Licence Number	L6950/1997/11
Licence Holder	Pilbara Iron Company (Services) Pty Ltd
ACN	107 210 248
File Number:	DER2014/000487
Premises	7 Mile Rail Yard Gap Ridge WA 6714 Legal description – Crown Lease GE I-123612 Lot 175 on Deposited Plan 26146
Date of Amendment	18 June 2018

Amendment

Amendment Notice

Attachment 4: Location of wastewater treatment plant

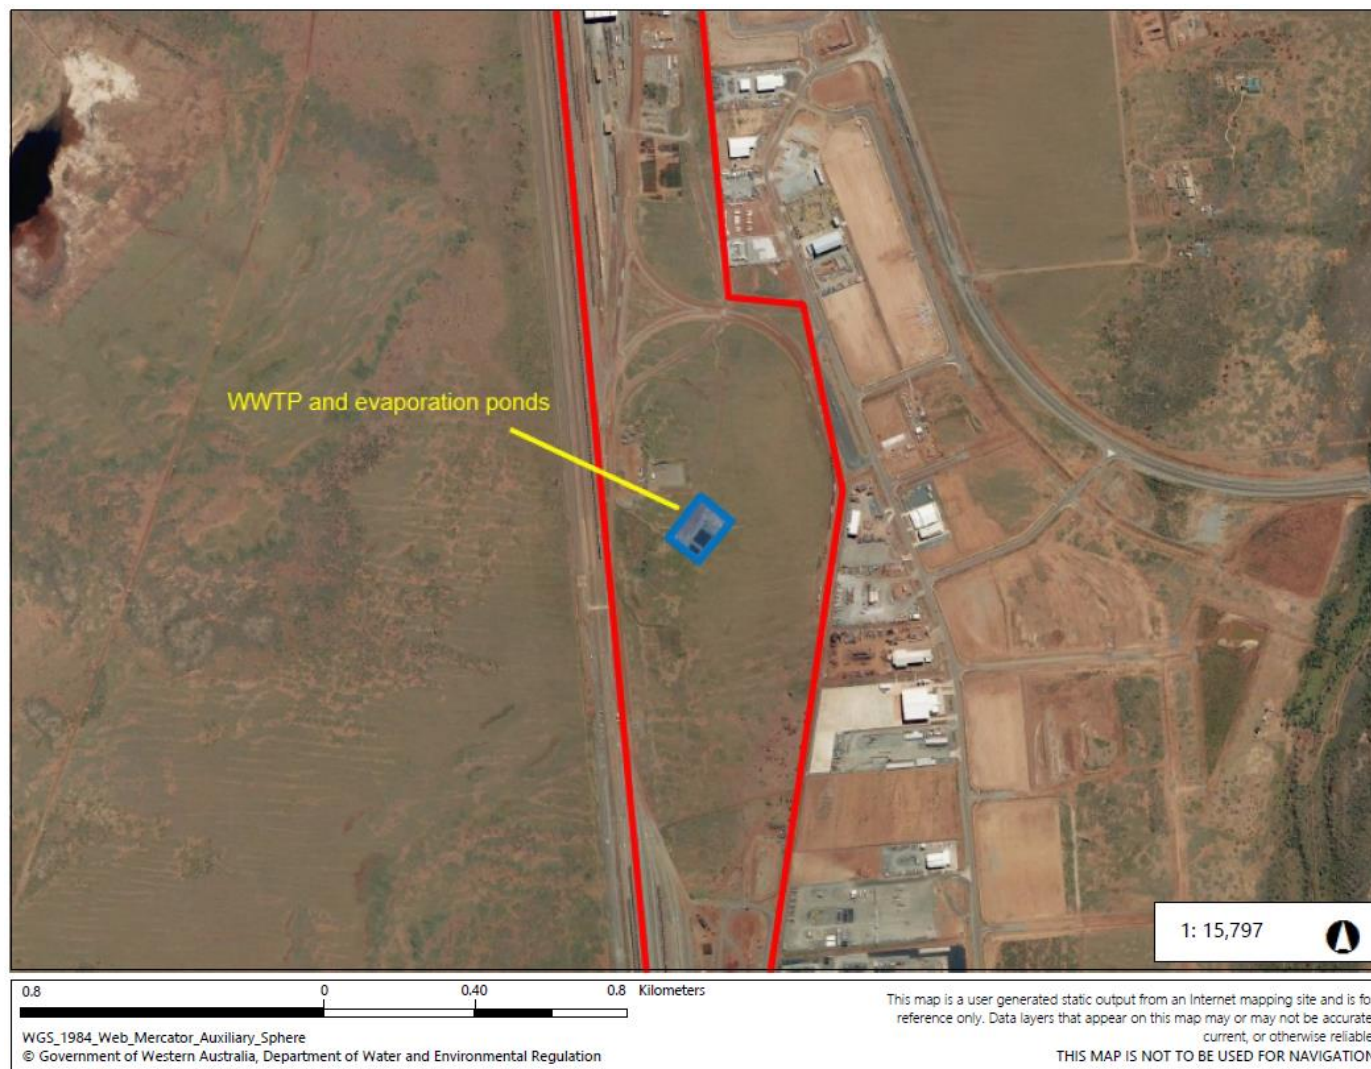
8. The following attachment is inserted after Attachment 3 within the Licence.

The location of the WWTP is indicated by the blue outline within the below map. The Premises boundary is indicated by the red outline.
